UNION TOWNSHIP BOARD OF TRUSTEES  
OCTOBER 10<sup>TH</sup>, 2023 MEETING

## ZONE MAP AMENDMENT

FIRST BAPTIST CHURCH OF GLEN ESTE, Applicant  
1030 Old SR 74, 1018 Old SR 74, Old SR 74,  
1028 Old SR 74, 1024 Old SR 74

### *Staff Report, Case# 5-23-Z:*

MASTER PLAN

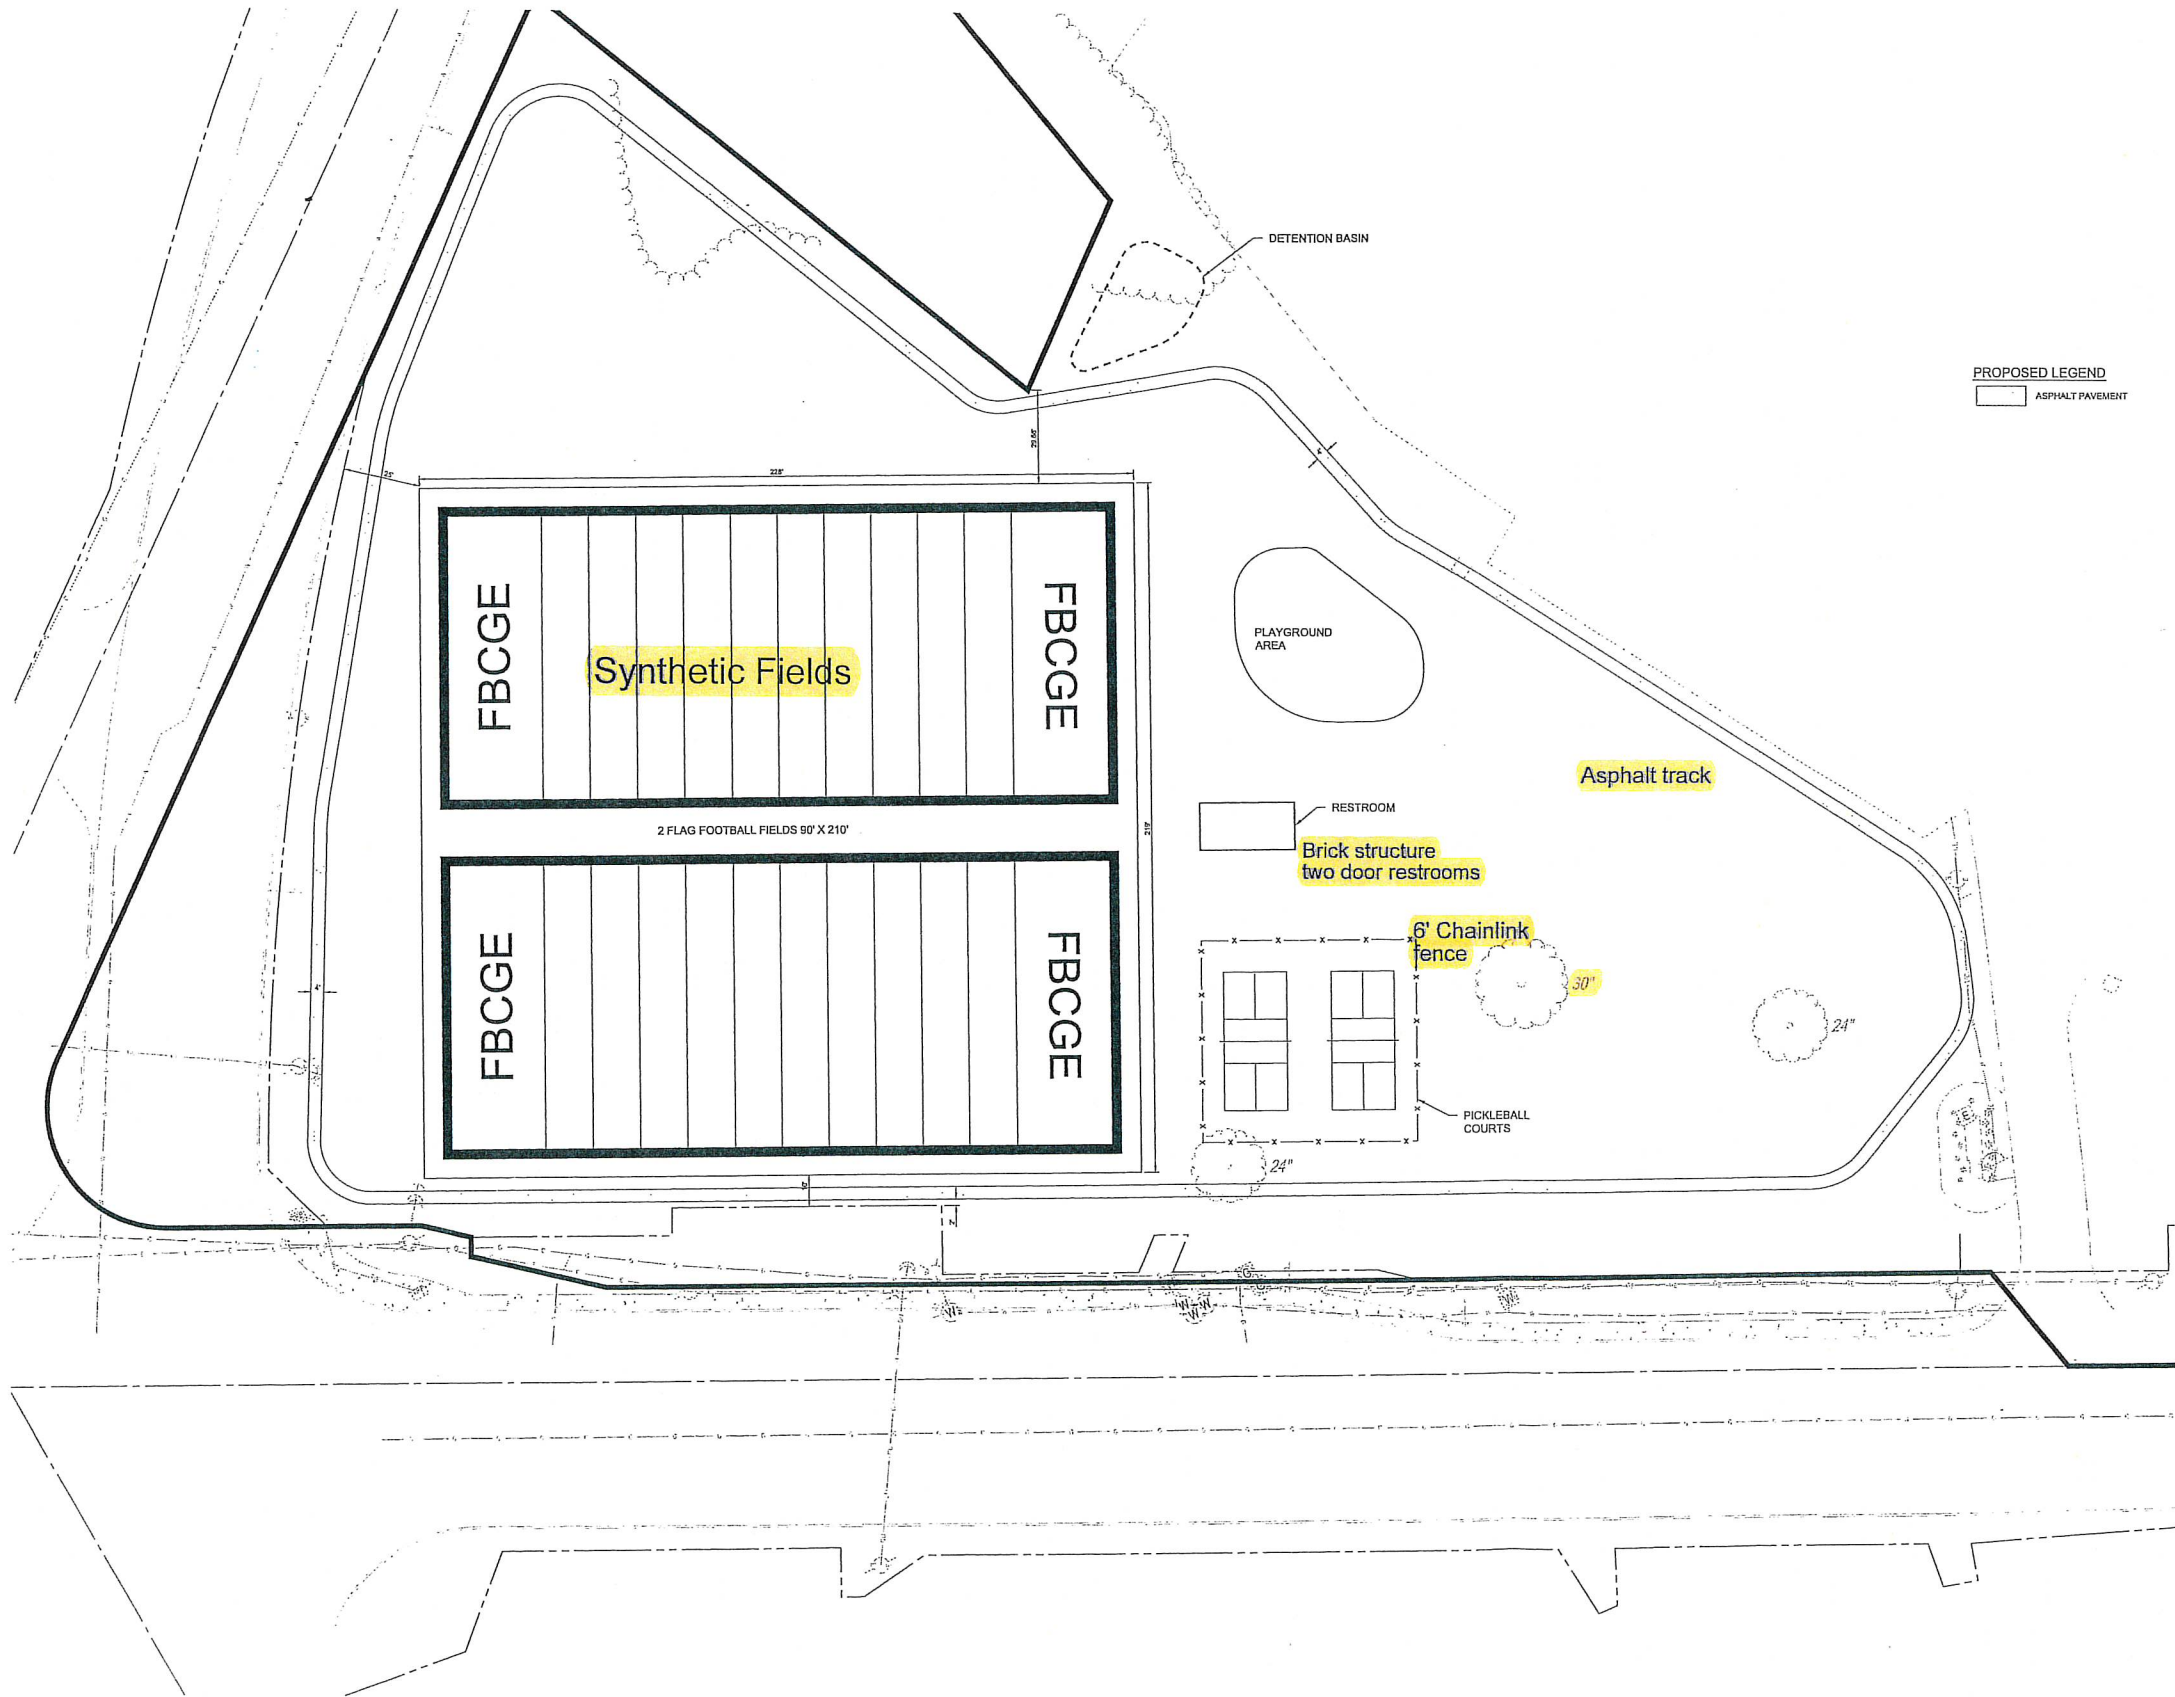
- 6) Staff recommends the consideration and use of vegetative buffering and landscaping strategies in the southwestern and northwestern portions of the site, particularly along the shared property lines with adjacent residential uses.

- 7) Staff recommends a 10-foot high fence to be established around the perimeter of the proposed pickleball courts—which is considered the standard height of pickleball enclosures.

- 8) The Applicant must move the proposed improvements on the Church's property approximately 20 feet more east, away from Tealtown Road, to alleviate safety concerns.
